Access Compliance Report

Public Rights-of-Way

(Curb Ramps)

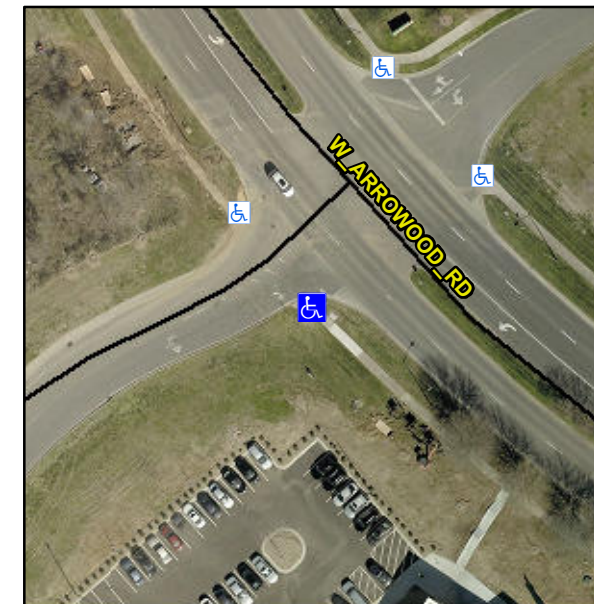
PROW/ADA:

R304.5.3

Compliance	Description	Data	Compliance	Description	Data
N/A	Ramp Length (in)	49.0	N/A	Grade Break?	N/A
Yes	Ramp Width (in)	56.5	N/A	Grade Break Slope (%)	0.0
Yes	Ramp Slope (%)	3.0	N/A	Grade Break XSlope (%)	0.0
No	Ramp XSlope (%)	4.0			
N/A	Flare Type LT	N/A	N/A	Flare Type RT	N/A
N/A	Flare Slope LT (%)	N/A	N/A	Flare Slope RT (%)	0.0
N/A	Flare Traversable LT?	N/A	N/A	Flare Traversable RT?	N/A
N/A	Landing Length (in)	0.0	N/A	DWS Provided?	N/A
N/A	Landing Width (in)	0.0	N/A	DWS Contrast?	N/A
N/A	Landing Slope (%)	0.0	N/A	DWS Length (in)	N/A
N/A	Landing X Slope (%)	0.0	N/A	DWS Full Width?	N/A
N/A	Landing Curb? (Y/N)	N/A	N/A	DWS Offset LT (in)	N/A
N/A	Shared Landing?	N/A	N/A	DWS Offset RT (in)	N/A
N/A	Gutter Ponding?	0.0	N/A	Gutter Slope (%)	N/A
N/A	Gutter Lip Ht (in)	0.0	N/A	Gutter X Slope (%)	N/A
N/A	Painted X Walk1?	No		Road Slope (%)	0.9
	X Walk 1 Direction	To NW		Road X Slope (%)	5.3
	X Walk 1 Width (in)	N/A		Clear Space?	N/A

Remove & Replace Entire Ramp.
